# 51 MELCHER

FORT POINT, SOUTH BOSTON, MA

FORT POINT CHANNEL LANDMARKS DISTRICT

09.21.2022

PROPOSED ELEVATION - SOUTH DOCK

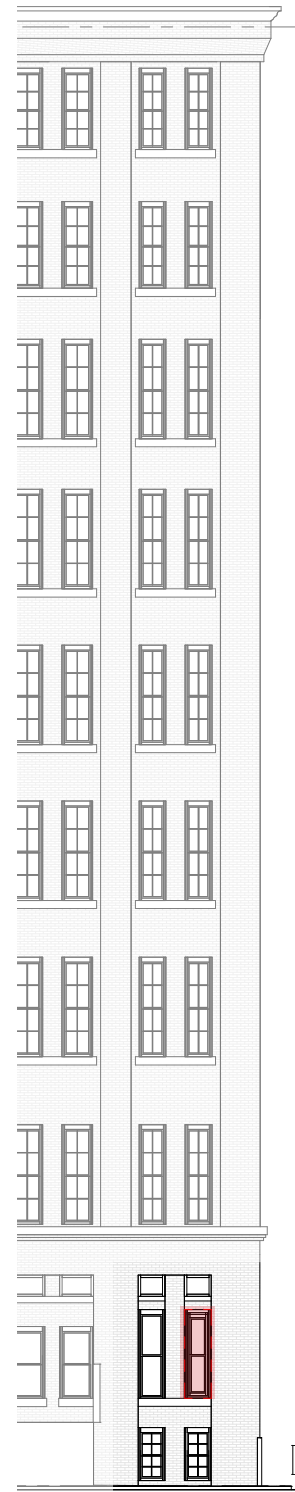
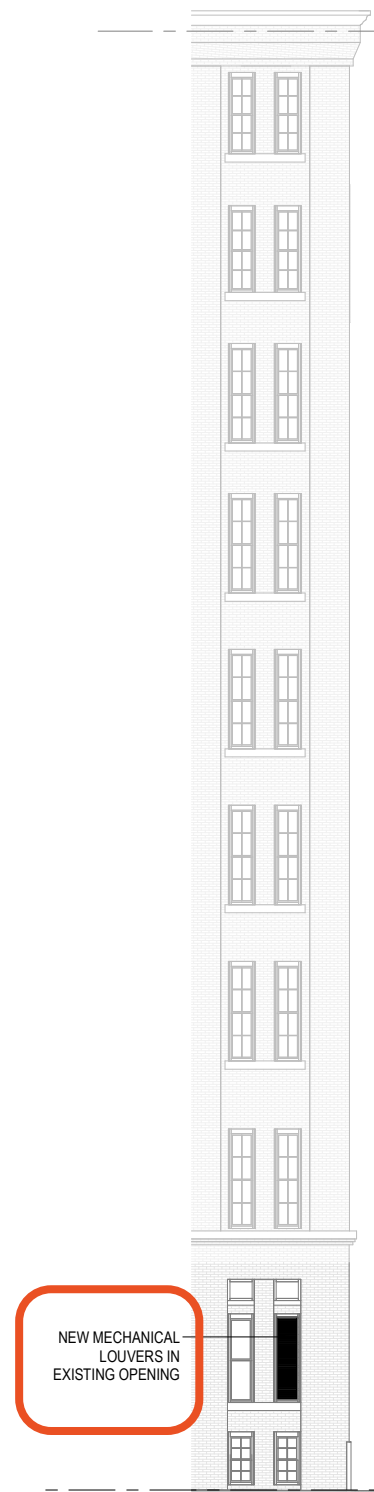
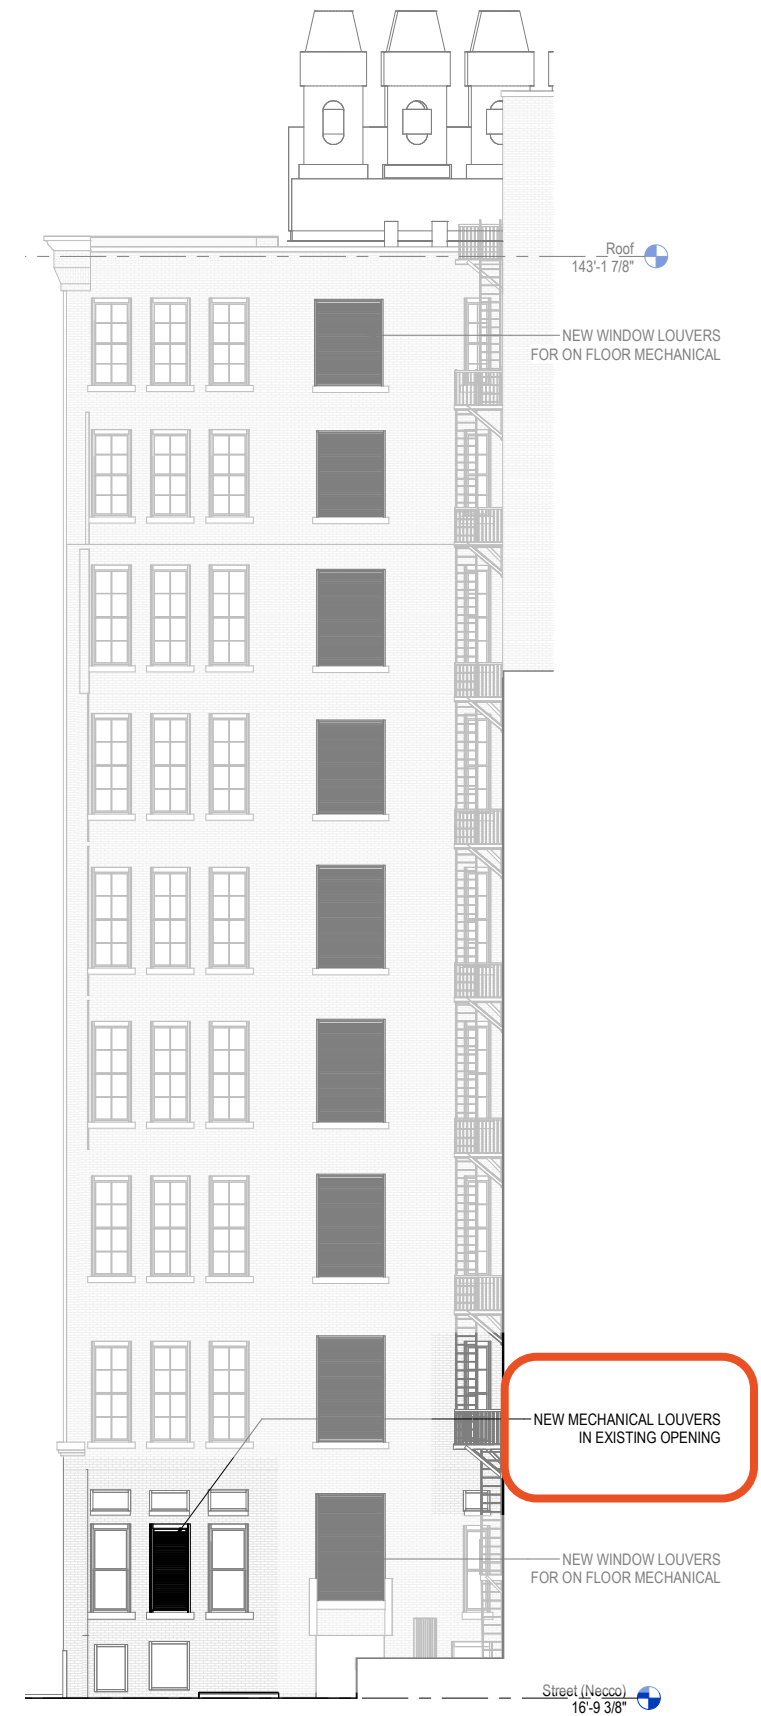
ONE OPENING ON EACH FLOOR TO BE REPLACED WITH LOUVER FOR ON FLOOR MECHANICAL INTAKE

WINDOW TO BE INFILLED WITH LOUVERS  
(2) WINDOWS NOT BEING REMOVED

NEW WINDOW LOUVERS FOR ON FLOOR MECHANICAL

UPDATED PLAN - PROPOSED DOCK

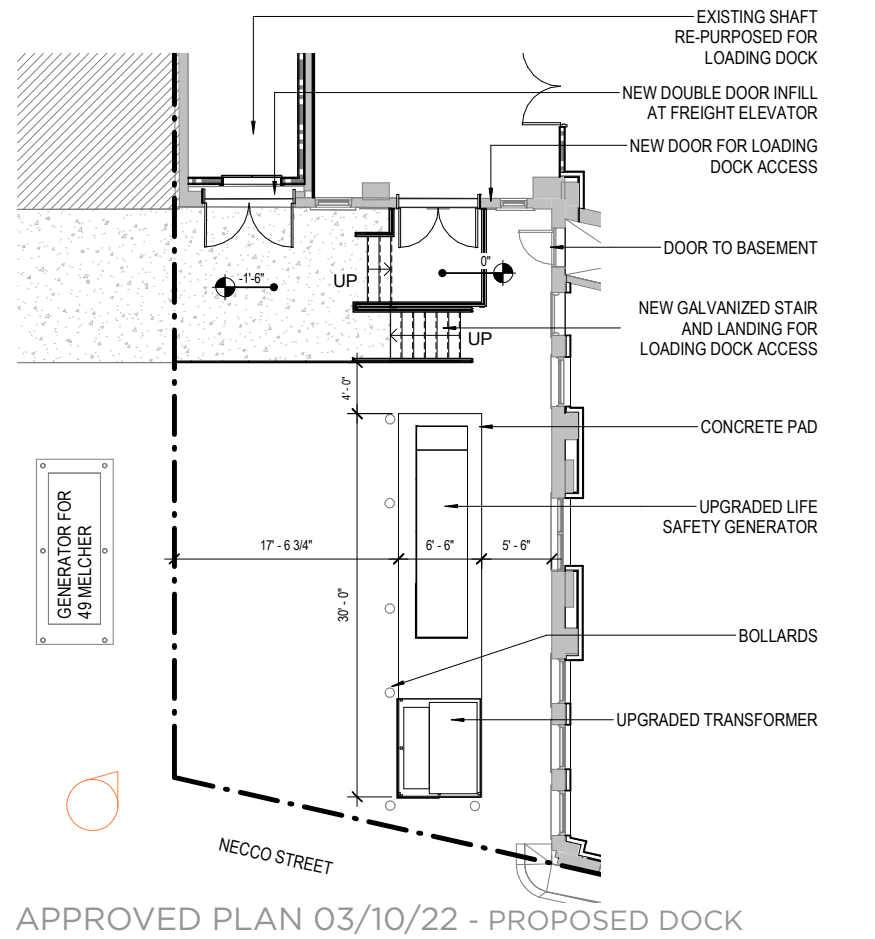
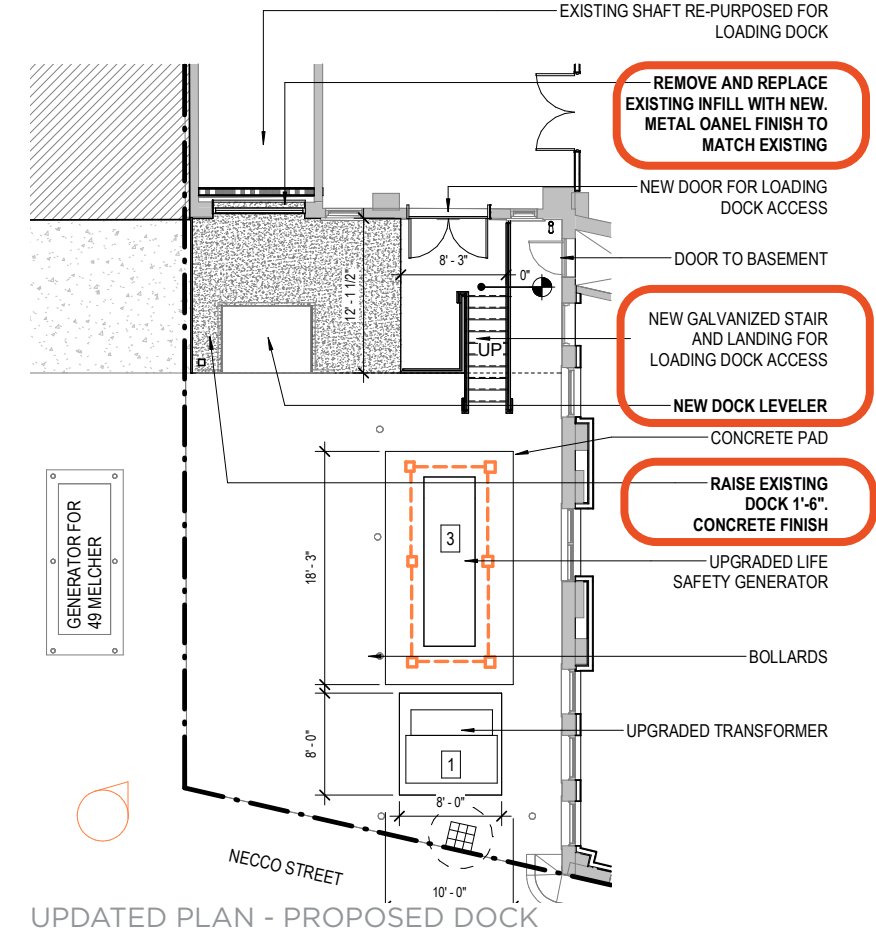
- **DOCK LEVELER ADDED AT REVITALIZED DOCK.**  
REASON: TO HELP WITH OFFLOADING AND EASE OF ACCESS.
- **CANOPY STRUCTURE CHANGE.**  
REASON: ADDED COLUMN AND REMOVED TIE RODS TO SIMPLIFY SUPPORT /  
REDUCE RENOVATIONS TO FACADE.
- **MISC WINDOW LOUVER CHANGES.**  
REASON: COORDINATION WITH ENGINEERING

GENERATOR: PREVIOUSLY APPROVED (GENERATOR TO RECEIVE CUSTOM PAINT TO MATCH TRANSFORMER GREEN)

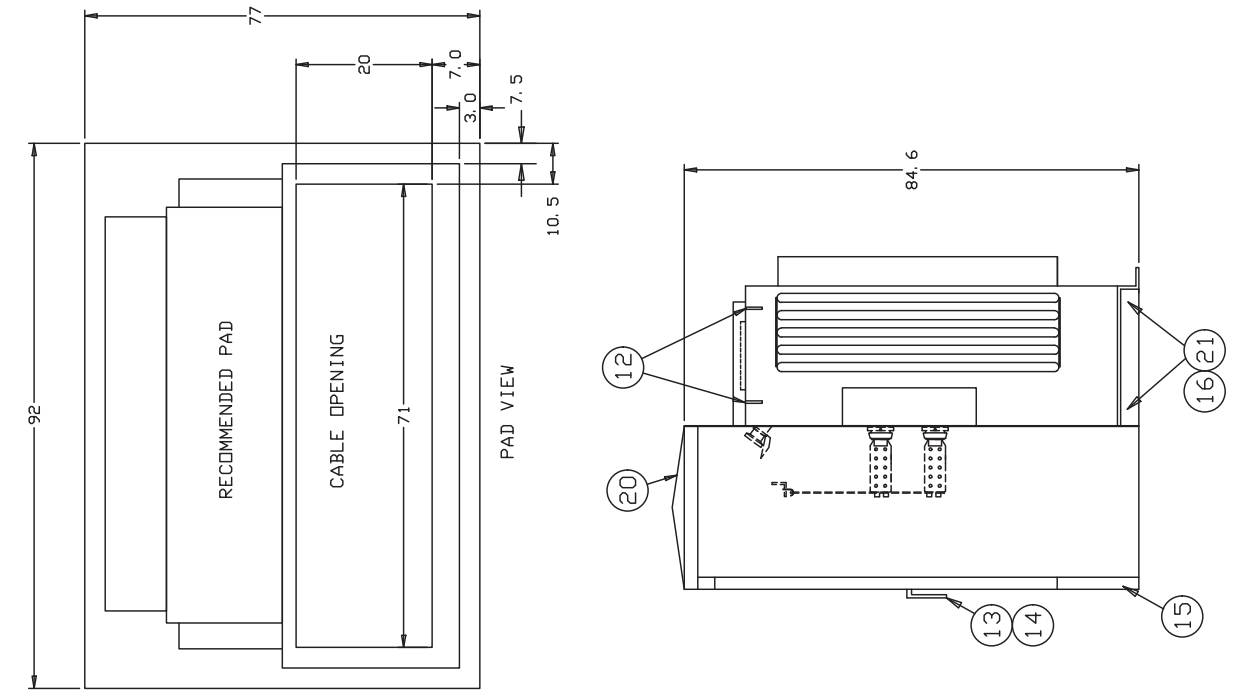
Determine if the generator and belly tank can be painted “Fort Point” green.

Generator and belly tank can be custom painted. Green will match other utility equipment at grade.
